Detailed Site Plan
Departure from Design Standards
Alternative Compliance
PMG Brooks Drive

DSP-20016
DDS-670
AC-20009

STAFF REPORT

SUBJECT: Detailed Site Plan DSP-20016
Departure from Design Standards DDS-670
Alternative Compliance AC-20009
PMG Brooks Drive

Figure 1: Site Development Plan

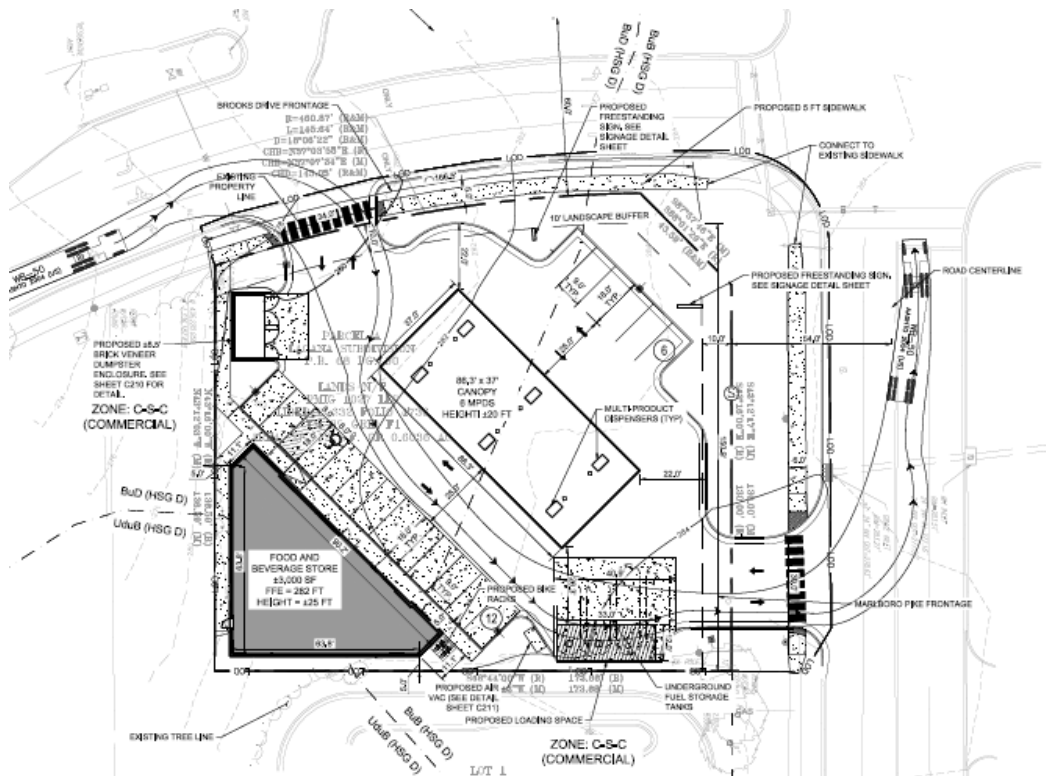
Half of the existing vehicular access points to the site are removed, with two points of access retained, one at the far western corner of the site, to Brooks Drive, and second at the far eastern corner of the site, to Marlboro Pike. Pedestrian and bicycle access to the building is provided by a sidewalk from Brooks Drive only. The provision of a pedestrian connection between the building and Marlboro Pike is also appropriate, but is not reflected on the DSP. A condition has been included in the Recommendations section for the provision of this pedestrian connection. A standard five-foot-wide sidewalk is provided along Brooks Drive and a six-foot-wide sidewalk is provided along Marlboro Pike. A total of 18 parking spaces are provided and the departure submitted requests to reduce the size of parking spaces to 9 feet by 18 feet, as discussed in Finding 7 below.

As shown on the plan, a five-foot-wide sidewalk provides a complete pedestrian connection between the proposed food and beverage store building and Brooks Drive. However, in reviewing this requirement relative to the site design guidelines contained in Section 27-274 of the Zoning Ordinance, as cross-referenced in Section 27-283 of the Zoning Ordinance, staff recommends that a clearly defined pedestrian connection also be provided between the building and Marlboro Pike. It is important to have one in this area as there is a bus stop along Marlboro Pike in front of the adjacent property, so there will be pedestrian traffic along this roadway in need of safe access into the site and to the building. A condition requiring such a connection to serve pedestrian traffic is included in the Recommendation section.

- 1. Prior to certification, the detailed site plan shall be revised, or additional information shall be provided, as follows:
 - a. Provide a pedestrian connection, in the form of sidewalks, pavement markings, or other facility, from Marlboro Pike to the entrance of the food and beverage store.

Figure 2: Food and Beverage Store Elevations

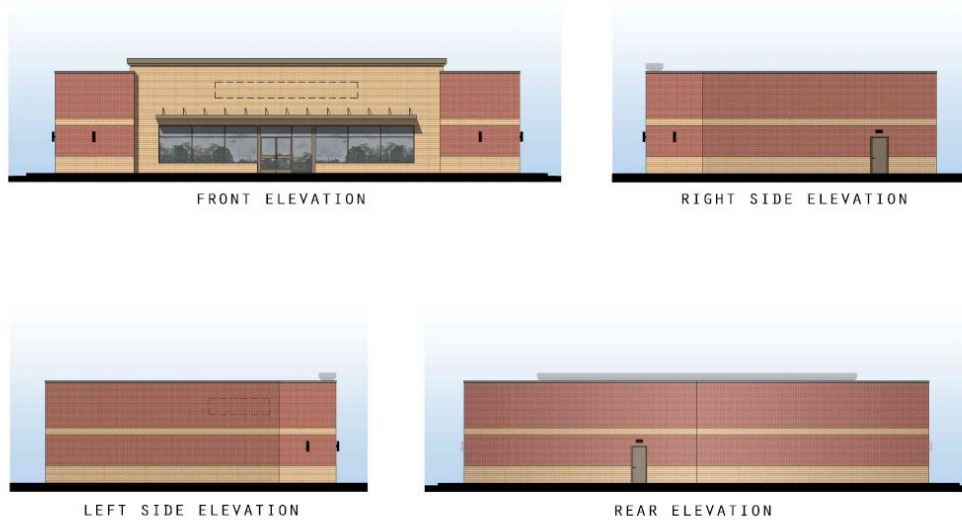
The proposed 3,000-square-foot food and beverage store is a 25-foot-high, single-story, triangular-shaped structure. The front façade of the building faces north, toward the interior of the site. Building elevation drawings do not provide dimensional data or details regarding façade treatments. A condition has been included in the Recommendation section for the plan to be revised to provide this information. Based on the elevations as submitted, appropriate fenestration is provided on the front façade, with no windows provided elsewhere on the building. Given the proposed use and configuration of the building on the site, the location and quantity of fenestration provided is acceptable. A raised cornice and lighter material coloration provided in the middle of the front façade adds interest to the design.

Architectural elevations of each façade of the proposed building and gas station canopy were provided. The images show structures that are compatible with existing development in the surrounding area. Complete details regarding the building's architecture, such as a schedule of exterior finishes, was not provided. A condition has been included in the Recommendation section to require the DSP to be revised to include this information.

- b. Provide dimensional data and labels of features and materials on all architectural elevations for the food and beverage store.
 - c. Revise the plan and signage table to include gas station canopy mounted signage data and demonstrate canopy mounted signage conforms with Section 27-613(c) of the Prince George's County Zoning Ordinance.

Figure 4: Signage Examples

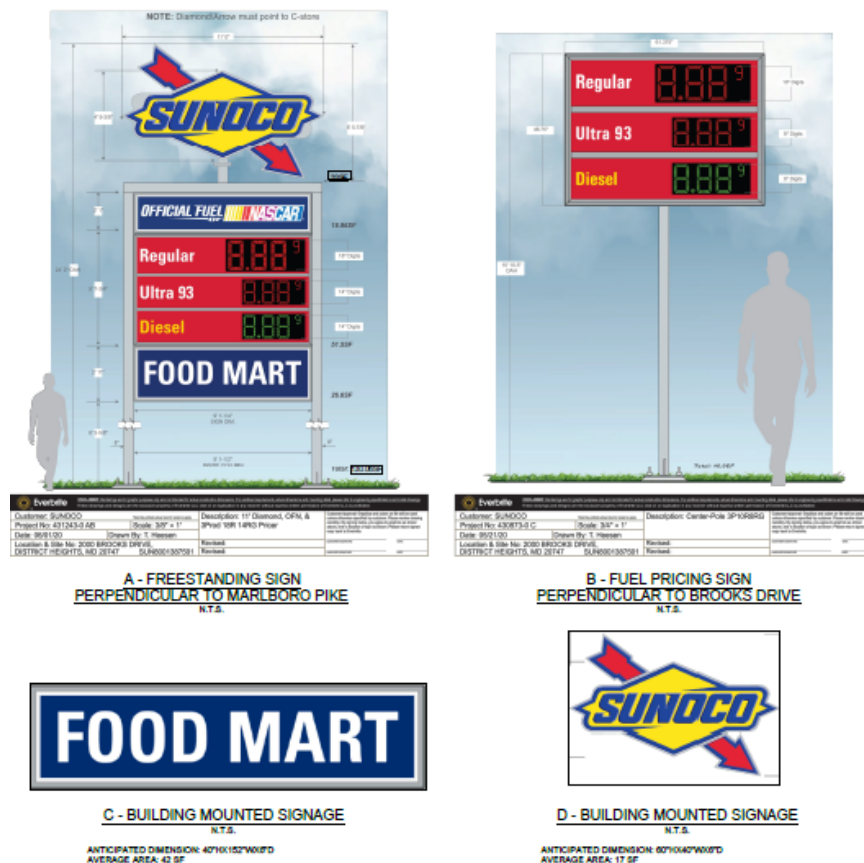
A comprehensive signage program is provided that includes freestanding, canopy-mounted, and building-mounted signs for the proposed gas station and food and beverage store. Building-mounted signage is designed in conformance with Section 27-613 of the Zoning Ordinance. Canopy-mounted signage area is not provided on the DSP and appears greater than permissible by Section 27-613(c). Details are provided for two freestanding signs, one with fuel pricing only, and a second larger sign with fuel pricing and business identity and advertising. Locations for both freestanding signs are shown adjacent to the intersection of Brooks Drive and Marlboro Pike. The second, smaller sign with fuel pricing only is permissible per Section 27-594(a) of the Zoning Ordinance, which requires a price sign at each entrance to the station. It is also in conformance with the requirements of Section 27-614(c)(6) of the Zoning Ordinance, relative to allowed area. A condition has been included in the Recommendation section for the signage plan to be revised to conform with Section 27-613.
